ENGINE - BIFURCATION PANEL - ADDITION OF STIFFENER PLATES AT RIVETED JOINT BETWEEN
UPPER AND LOWER PANELS - CATEGORY CODE 6 - MOD.ENG-72-0088

V2500-ENG-72-0088

Part 1 Location of bifurcation panel
Fig.1

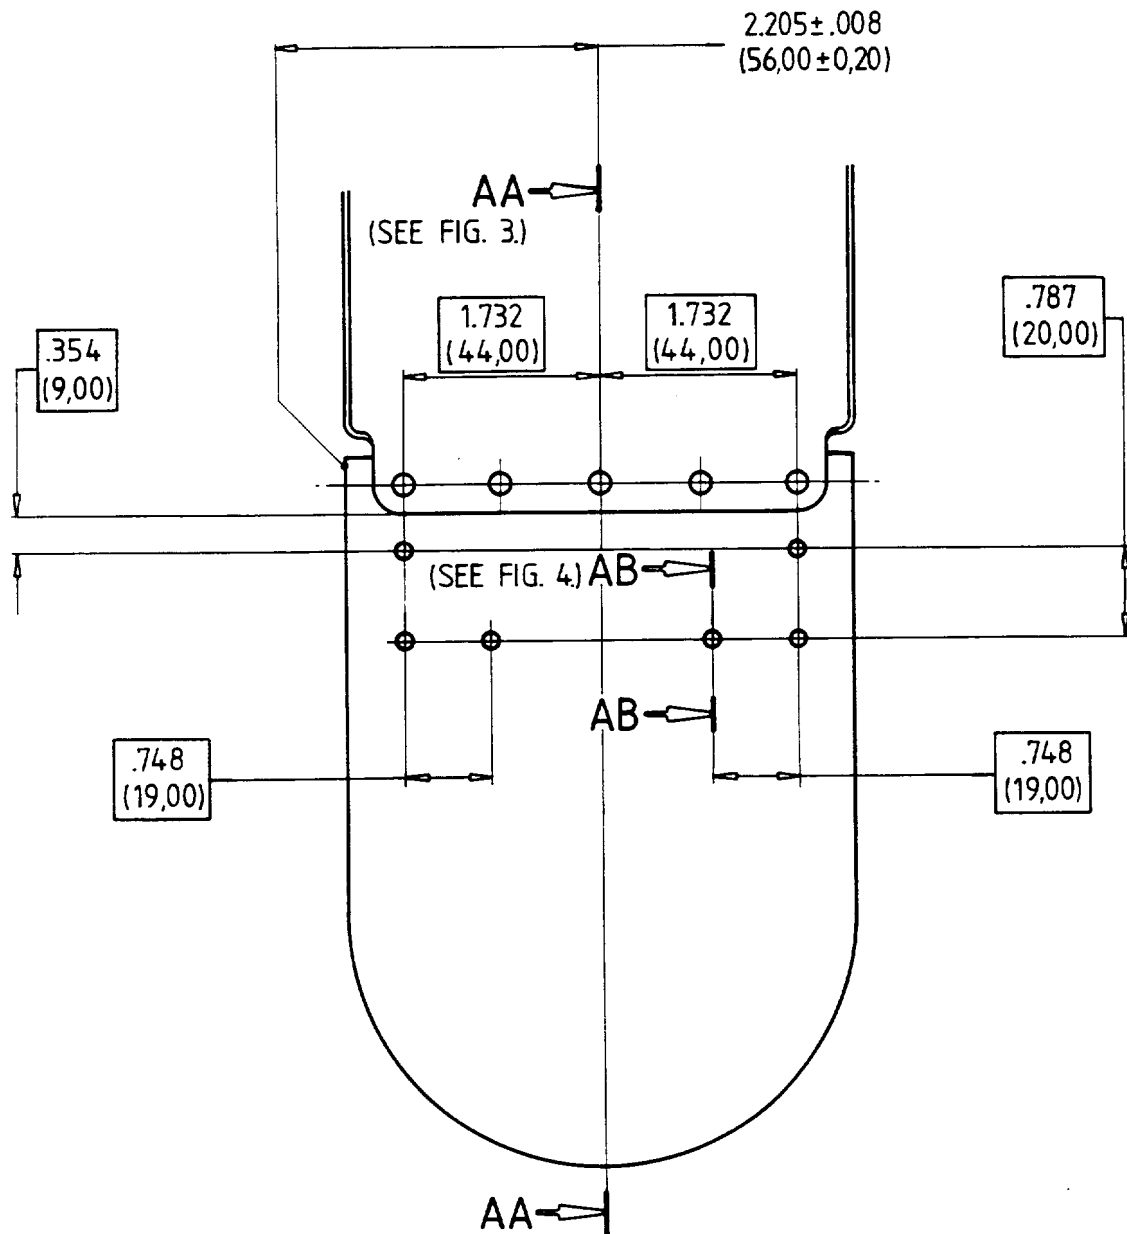
- (i) The lower portion of the bifurcation panel has been modified such that two stiffening plates have been riveted between the lower and upper panel edges to maintain seal efficiency and strengthen the panel.
- (ii) The opportunity is also taken to delete an unused hole in the panel which was originally required for an instrumentation lead. The associated blanking plate and attaching parts become redundant.

REMOVE 6A3361 PANEL AND
INSTALL 6A4624 PANEL

- (1) New 6A4624 panel assembly is interchangeable with in use panel assembly.
- (2) Assemble new or re-identified 6A4624 panel assembly by use of approved procedures, Engine Manual, 72-38-25, Assembly.

Rework of bifurcation panel
Fig.3

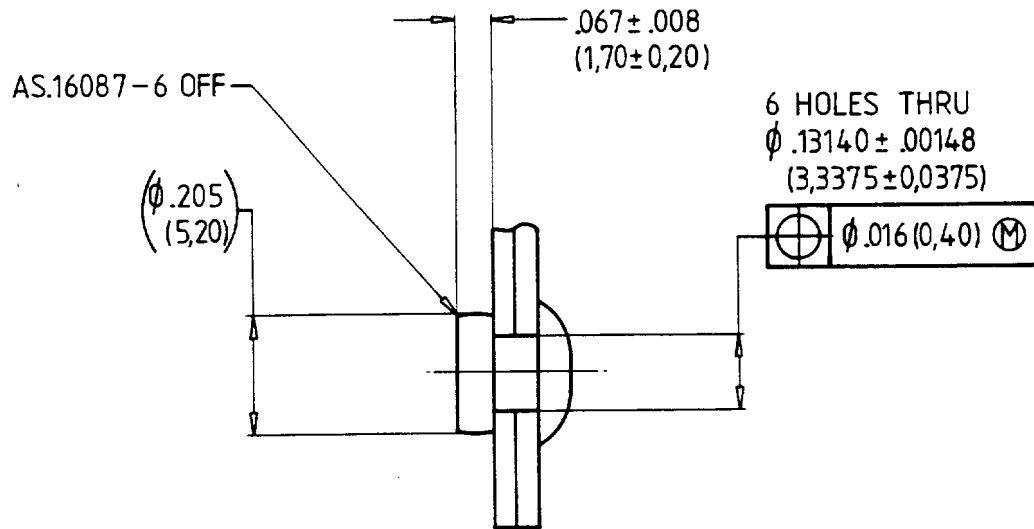
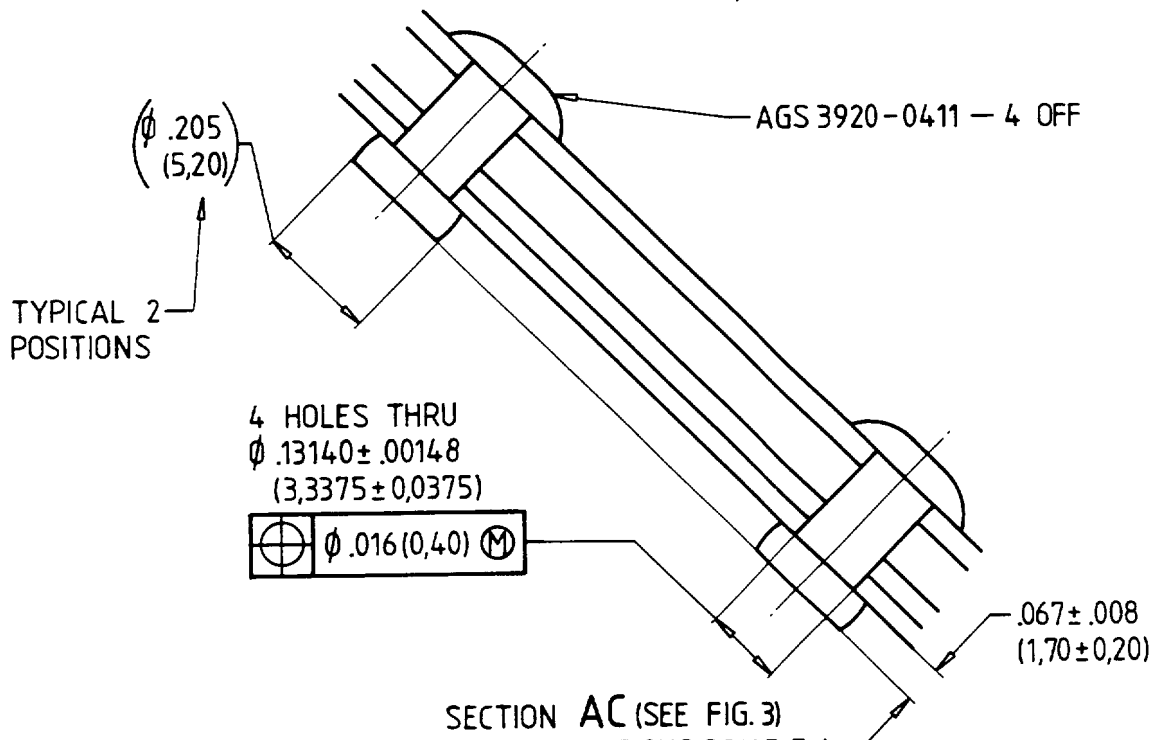
Special tools are not required, however use of a locally manufactured template will assist in rework operations, refer to Figure 3 and Accomplishment Instructions.

Procedure	Supplementary Information
(i) Remove the applicable parts of the sealing retaining strips by removal of rivets	See Figure 3 and Figure 4. Use basic workshop tools
(ii) Remove the applicable section of rubber seal	See Figure 3. Use a sharp knife. Cut along the glue line
(iii) Locate template through the two holes of the panel, 6A3361	See Figure 3. Use locally made template. Use basic workshop tools
(iv) Mark the applicable three holes on each side of the panel, 6A3361	See Figure 3. Use basic workshop tools
(v) Remove template	
(vi) Drill the applicable three pilot holes on each side of the panel, 6A3361	See Figure 3. Use basic workshop tools
(vii) Examine	Make sure holes are correctly drilled
(viii) Clamp the stiffening plates, 6A4657 and 6A4658, onto panel 6A3361 and drill sixteen rivet holes as shown	See Figure 2 and Figure 3. Use basic workshop tools

SECTION AA
(SEE FIG. 2)
TYPICAL BOTH SIDES.
PART 1

Part 1 Rework of bifurcation panel
Fig.5

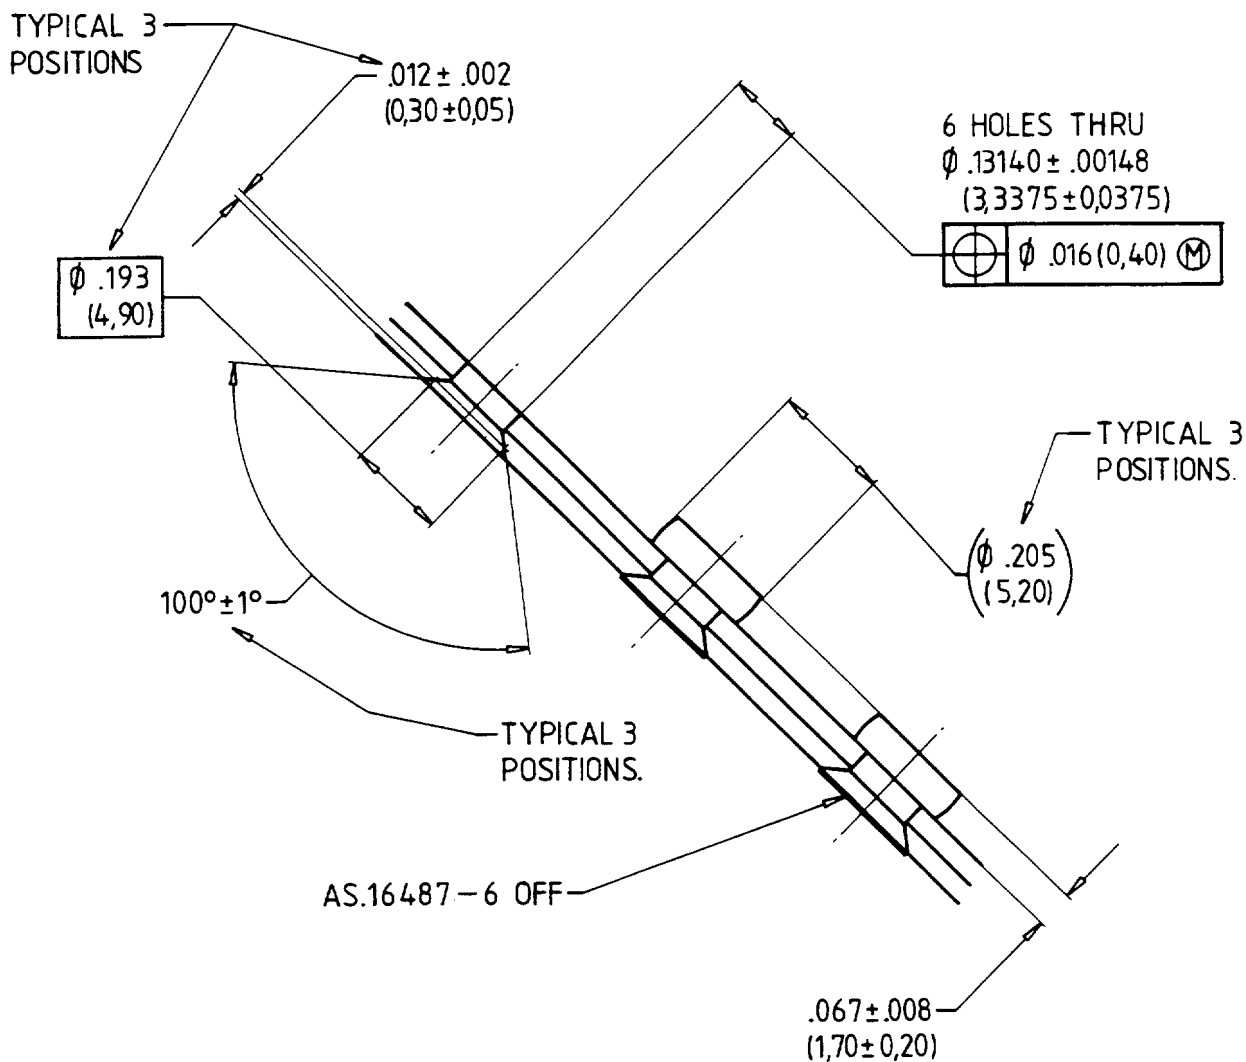
- | | | | | | |
|--|---|--------------|--------------|--------|--------|
| (xi) Countersink the six holes where shown | See Figure 5.
Use basic workshop tools | | | | |
| (x) Remove all sharp edges from new holes | Use basic workshop tools | | | | |
| (xi) Assemble stiffening plates, 6A4657 and 6A4658, to panel 6A3361. Fit rivets into countersunk holes | See Figure 3 and Figure 5.
Use AS16487 rivets, solid countersunk head, six off.
Use basic workshop tools | | | | |
| (xii) Fit rivets into holes at foot location | See Figure 2, Figure 3 and Figure 4. Use AS16087 rivets, solid universal head, six off.
Use basic workshop tools | | | | |
| (xiii) Replace rubber seal sections and bond in place | See Figure 3. Refer to Standard Practices/Processes Manual TASK 70-36-02-360-501, SUBTASK 70-36-02-360-020.
Use CoMat 08-013 Silcoset 152.
Use basic workshop tools | | | | |
| (xiv) Replace seal retaining strips and secure with rivets | See Figure 3 and Figure 4.
Use AGS3920-0411 rivets, blind snaphead, sixteen off.
Use basic workshop tools | | | | |
| (xv) Examine | Make sure rivets are tight | | | | |
| (xvi) Cancel the old part number and identify with the new part number | <table border="0"> <tbody> <tr> <td>Old Part No.</td> <td>New Part No.</td> </tr> <tr> <td>6A3361</td> <td>6A4624</td> </tr> </tbody> </table> <p>Refer to Standard Practices/Processes Manual TASK 70-09-00-400-501, SUBTASK 70-09-00-400-001.
Use vibro-engraving equipment</p> | Old Part No. | New Part No. | 6A3361 | 6A4624 |
| Old Part No. | New Part No. | | | | |
| 6A3361 | 6A4624 | | | | |

SECTION AD (SEE FIG. 3)
TYPICAL 2 POSITIONS, SCALE 5:1.
RIVET & P-SEAL REMOVED FOR CLARITY.
PART 1

Part 2 Rework of bifurcation panel
Fig.6

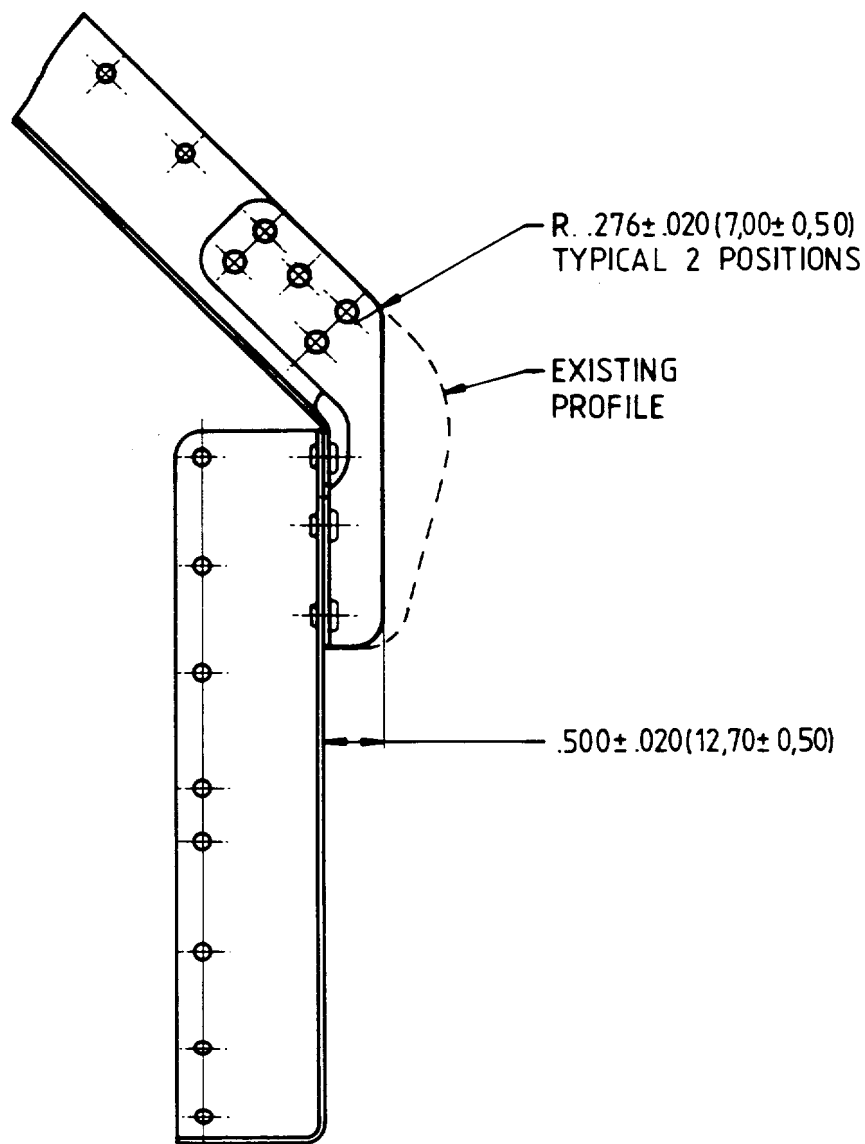
- (i) Spare engines and spare bifurcation panel assemblies were delivered to operators with incorrect standard of stiffening plates fitted to the bifurcation panel.
- (ii) Bifurcation panels can be reworked.

(i) Mark off area for removal

See Figure 6.
Use basic workshop tools

(iii) De-burr and remove sharp edges

See Figure 6.
Use basic workshop tools

See Figure 6
Measure the dimension and ensure that the edges are smooth

VIEW SHOWING REWORKING OF EXISTING PANELS
TYPICAL FOR RIGHT & LEFT HAND STIFFENER PLATES
SCALE: SIZE
PART 2
